**SUBJECT:** Comanche Peak Nuclear Power Plant, Docket Nos. 50-445 AND 50-446,  
First Six-Month Status Report in Response to March 12, 2012, Commission Order  
Modifying Licenses with Regard to Requirements For Mitigation Strategies For Beyond-  
Design-Basis External Events (Order Number EA-12-049) (TAC NOS. MF0860 and  
MF0861)

## **Comanche Peak Nuclear Power Plant's (CPNPP) First Six Month Status Report for the Implementation of Order EA-12-049, Order Modifying Licenses with Regard to Requirements for Mitigation Strategies for Beyond-Design-Basis External Events**

Figure A3-14: Modified 2323-S-0815 Pipe Routing for Spent Fuel Pool Secondary Connection (Reference 8n)

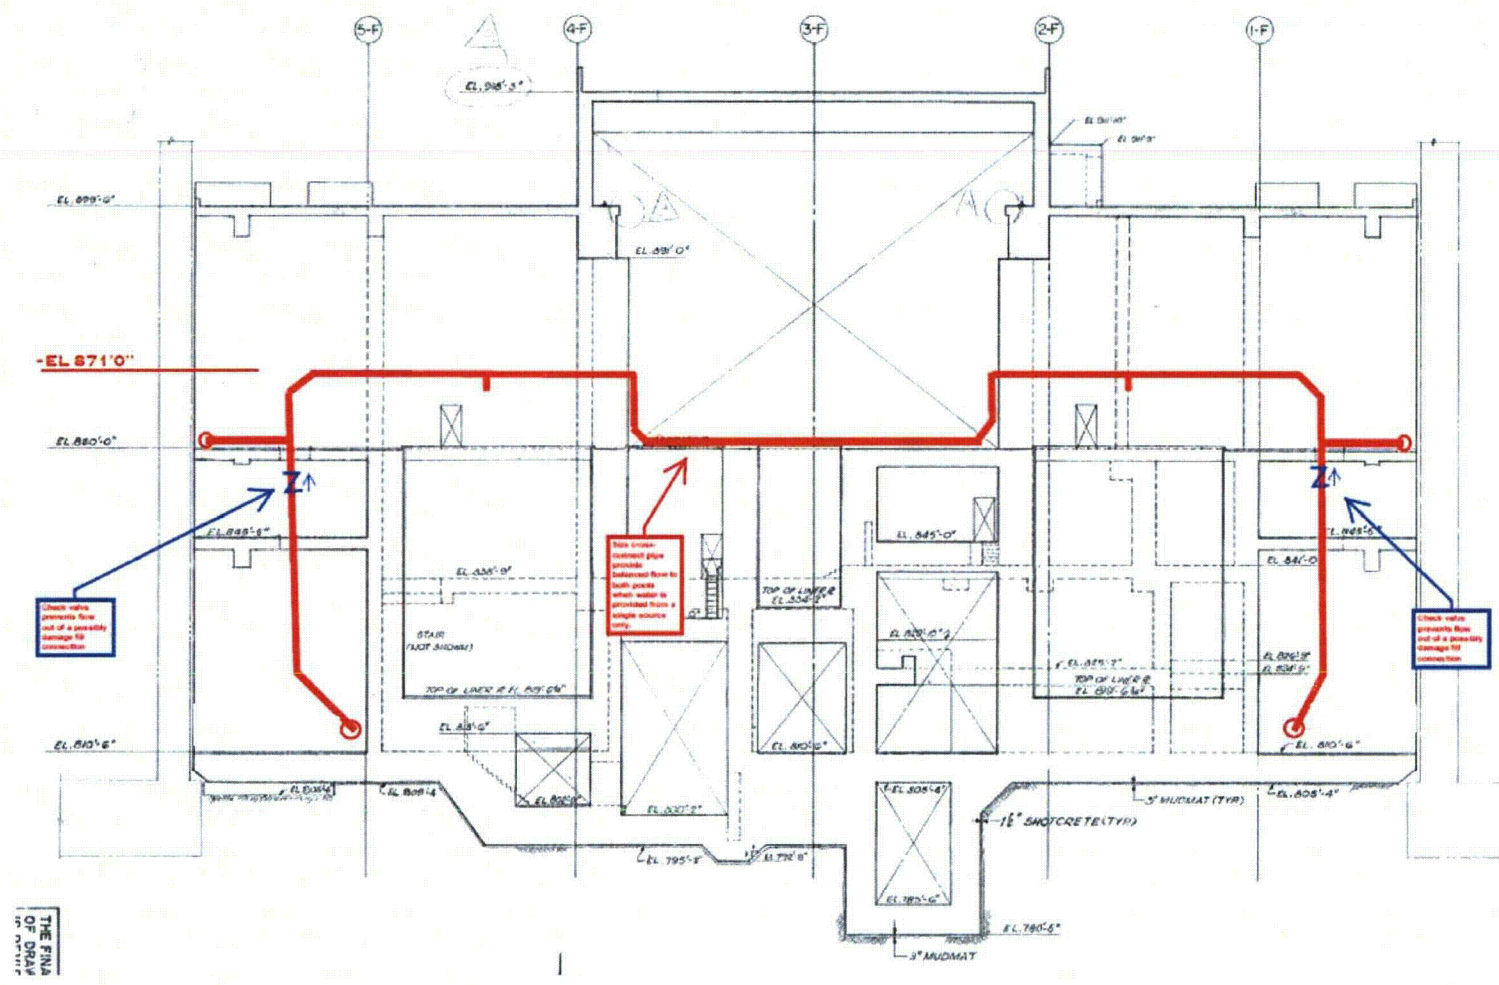
Pages	Location	Action
59	Second column first item	Change condensate line to <i>pipng connected to CST</i>
59	Second column Unit 2 description	Delete Unit 2 and its description
59	Second column item 3	Change Two to <i>Four</i> Change 1 to 2
59	Second column items 4 and 5	Change 2 to <i>Four</i>
63	SSI and SCR sections third column	Delete last sentence and replace with: <i>The connection will be via a hose and submerged eductor arrangement.</i>
65	Second column item number 2	Delete item number 2 and its description, replace with: 2. A 4"x4"x4" tee will be added along RWST overflow line 4-CT-1/2-073-152R-5.
78	Action Item 12 second and fifth columns	Change 2 to 1
83	Figure A3-1	Replace with Figure A3-1 from Appendix A
84	Figure A3-2	Replace with Figure A3-2 from Appendix A
86	Figure A3-4 title	Change Secondary to <i>Primary and Secondary</i>
93	Figure A3-11	Replace with Figure A3-11 from Appendix A
96	Figure A3-14	Replace with Figure A3-14 from Appendix A

Figure A3-16: Modified A1-0413, Sh. 02 Primary FLEX Connections EL. 810'-6" (Reference 8,q)

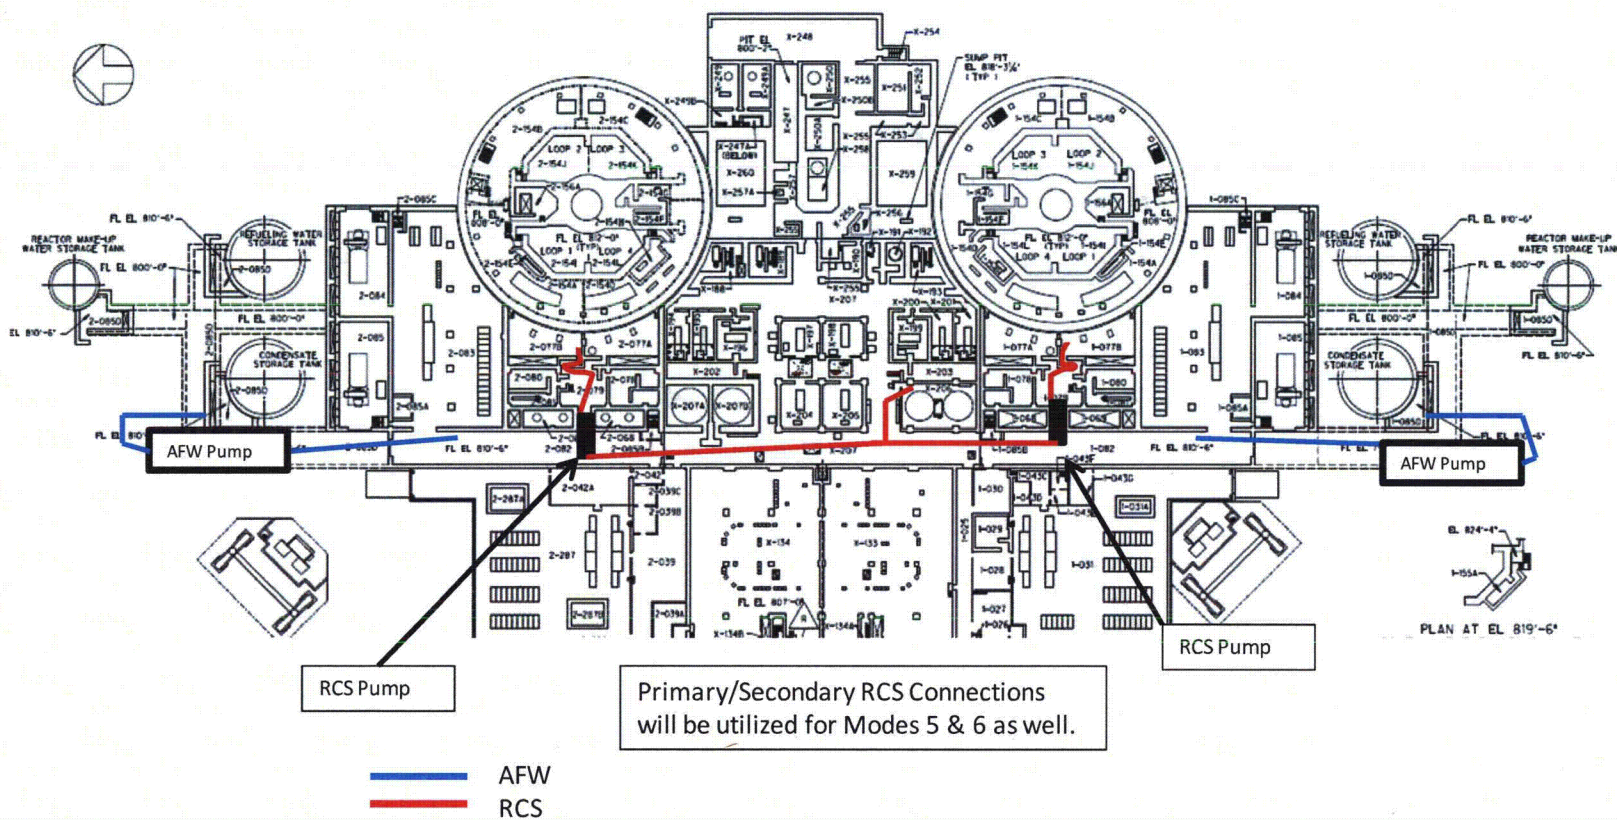
98	Figure A3-16	Replace with Figure A3-16 from Appendix A
101	Figure A3-19	Replace with Figure A3-19 from Appendix A
103	Figure A3-22	Delete
110	Figure A3-30	Delete
112	Figure A3-33*	Replace with Figure A3-33 from Appendix A

Figure A3-34: Modified A1-0413, Sh. 02 FLEX Staging Areas (Reference 8q)

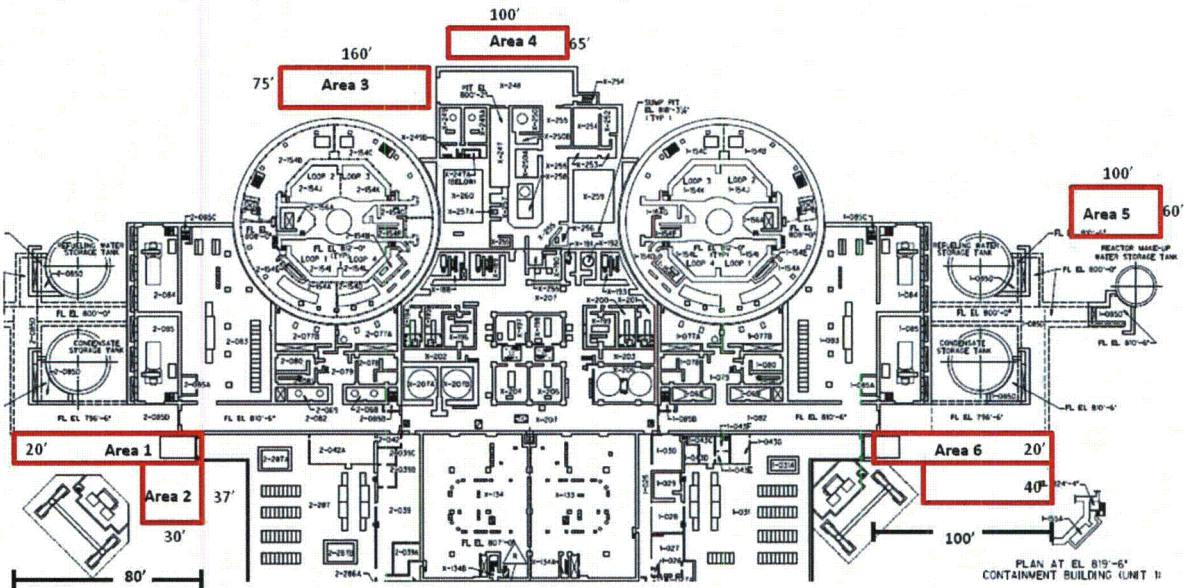
\* Note Figure A3-34 has not changed but is located on the same page as Figure A3-33.
